Job Number 1938

### Comment Response - Mystique Way Development

Please find our responses to the comments that were outlined in your review memo regarding the Mystique Way Amendment. The comments are listed below followed by our responses in italics.

DATE:	3/6/2020
SCALE:	AS SHOWN
DESIGNED:	JDA
JOB NO.:	1938
FILE:	1938 S.DWG
SHEET	<b>E-2.0</b>

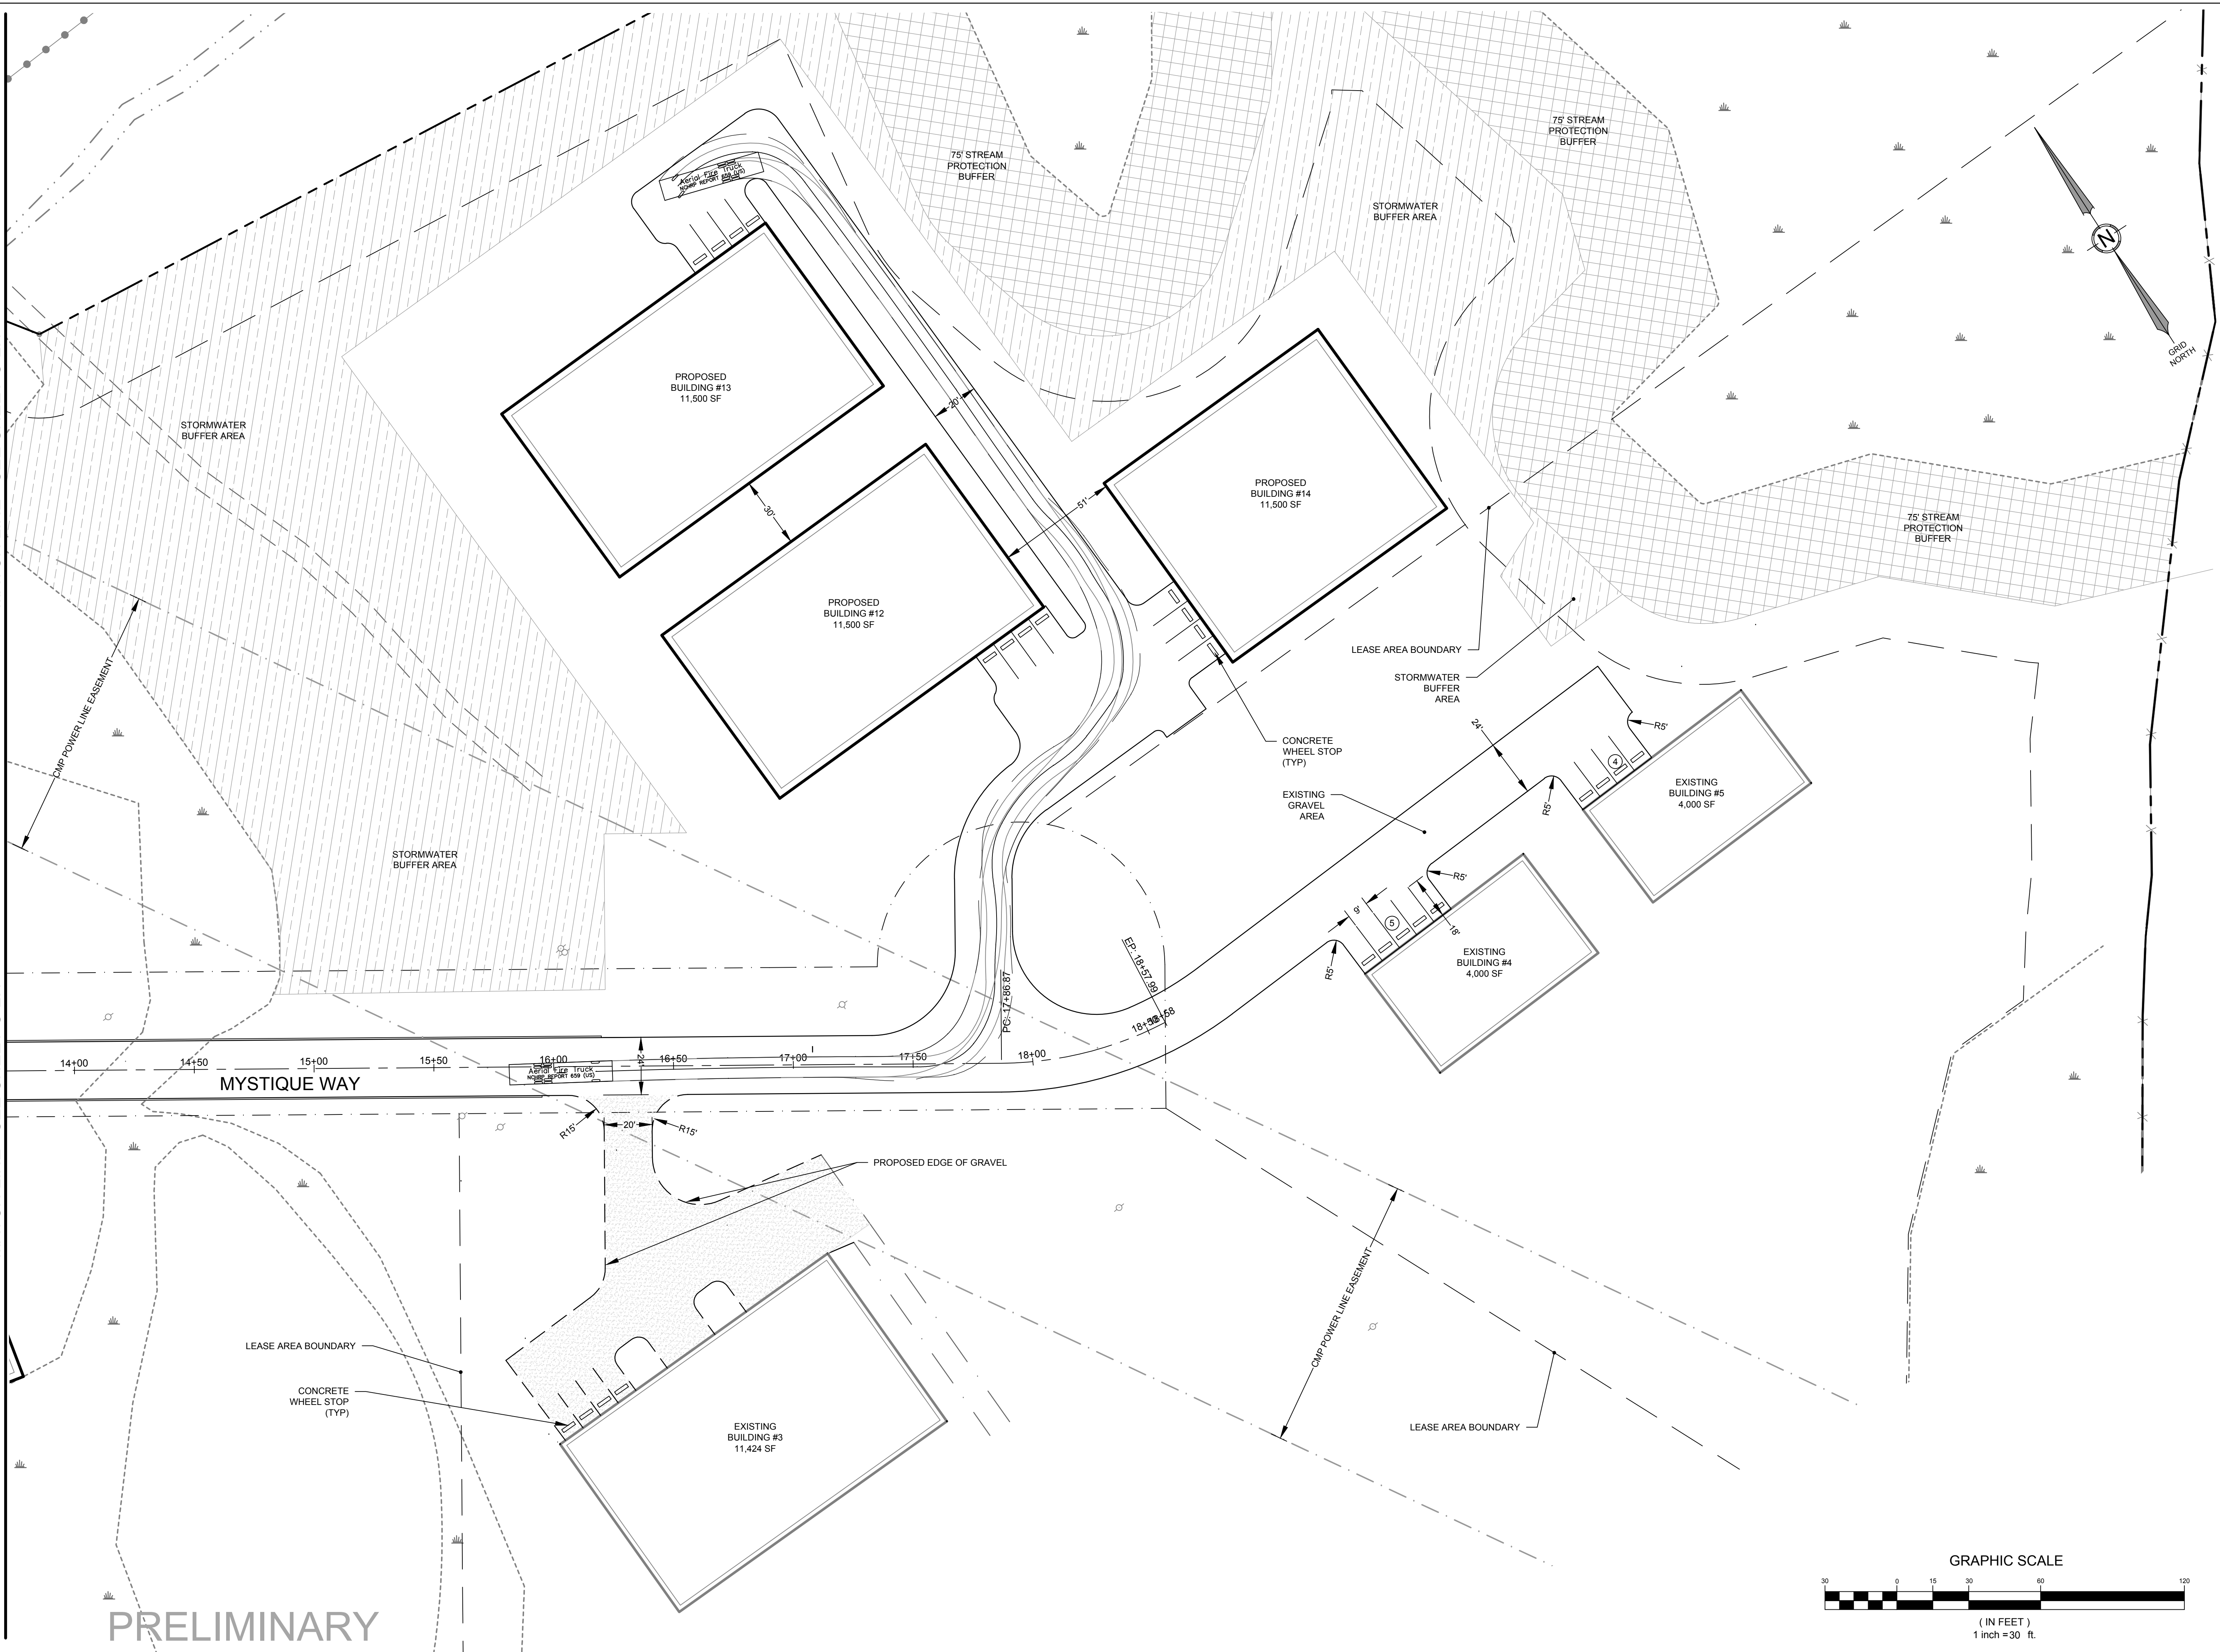
10. Address all concerns raised by the Fire Department regarding access and fire hydrant distances.

*Response: We have performed an Autoturn analysis of the area in question. Exhibit #2 shows the results. As you can see, a 43' long ladder truck has no difficulty maneuvering to the rear parking lot.*

*The fire chief was concerned about the condition of the existing access road nearest the existing units located at the end of the road. That access road is a temporary driveway. The road will be constructed per the details shown on our plan set. It will be properly compacted and then paved. Once completed, all access roads, parking lots and driveways will be easily accessible to traffic.*
